Work Order ID 96873

Item Name: Crosstube Mid Fwd, Blue

DRAWING NO. D206-667-147	TITLE CROSSTUBE ASS'Y (206L MID FWD)	REV. A	DART AEROSPACE LTD ENGINEERING ORDER		D.E.O. NO. D206-667-147-A-1	SHEET NO. SHEET 1 OF 1	SCALE NTS
DRAWN <i>qp</i>	CHECKED <i>ASS</i>	MFG. APPR. <i>JB</i>	APPROVED <i>MD</i>		DE APPR. <i>MD</i>		
DATE 11.07.15	DATE 11.07.20	DATE 11.07.21	DATE 11/07/21		DATE 11.07.21

DETAIL P
BONDING STRAP INSTALLATION 2 PL

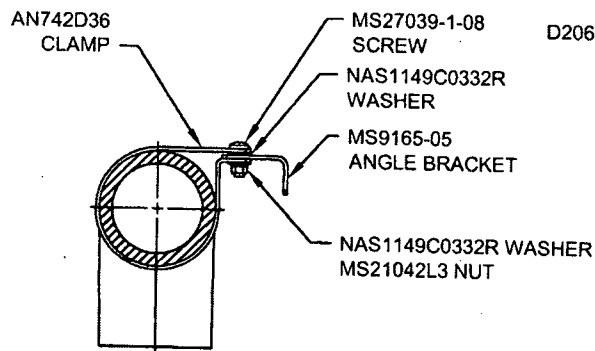
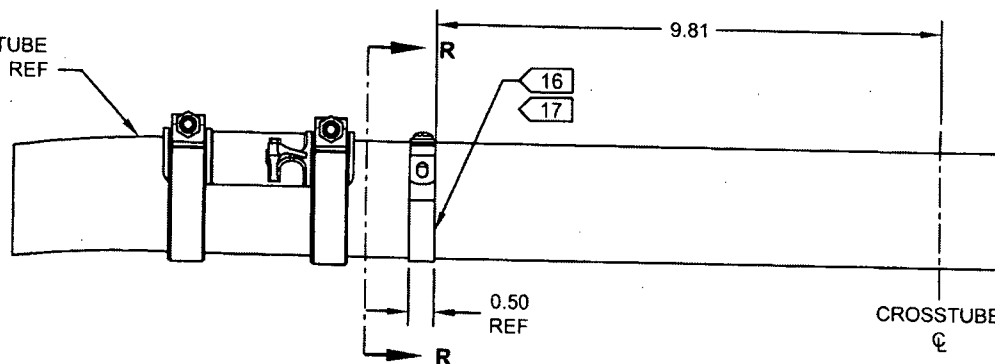
ADD ELECTRICAL GROUNDING STRAP

- 16) MASK AREA UNDER CLAMP PRIOR TO PAINTING
- 17) SEAL EDGES WHERE AN742D36 CLAMP MEETS WITH THE CROSSTUBE USING SIKAFLEX-241/291 OR MIL-S-8802 CLASS B2 OR PROSEAL 890 SEALANT
- 18) PERFORM RESISTANCE CHECK TO ENSURE MAX RESISTANCE IS 10 MILLIOHMS
